#9093 REEL HOLD DOWN KNOB

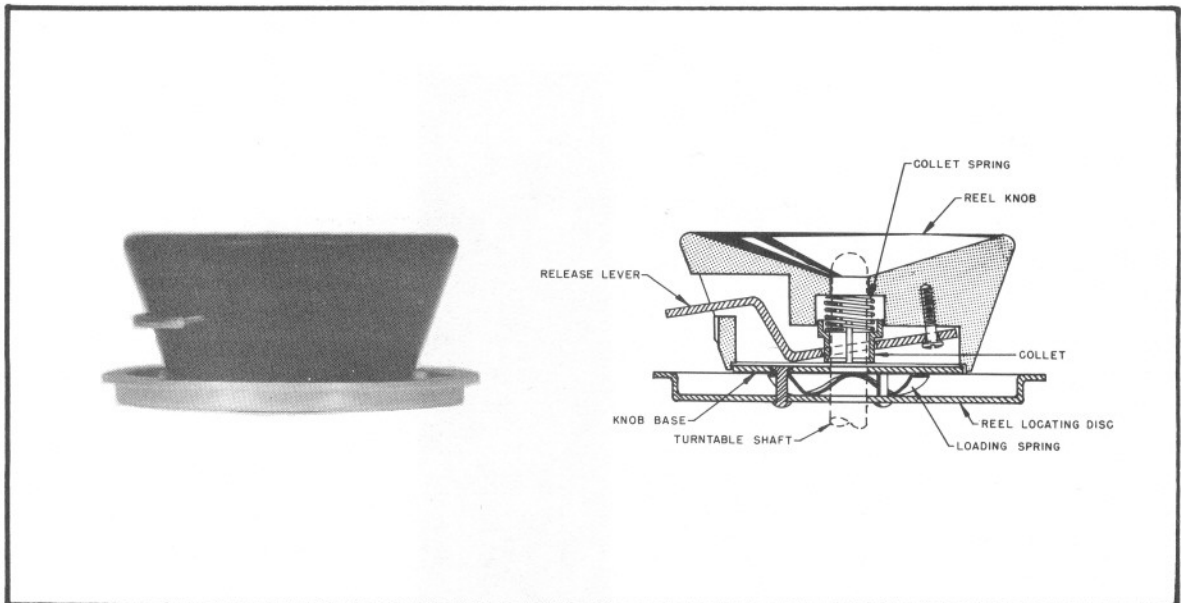
All rack mounted Recorders require Hold Down Knobs on the turntable shafts to keep the reels from slipping off. For this purpose the #9093 Reel Hold Down Knob is supplied with rack mounted machines. This knob replaces the #4402 Knob.

The #9093 Knob has a simple, positive action. It is slipped on the turntable shaft with the concave side facing outward, and is pressed down firmly so that the reel locating disc is engaged in the center of the reel. A spring loaded collet within the knob engages the turntable shaft. The Knob is self-centering, as the knob base is mechanically coupled to the reel locating disc through a loading spring.
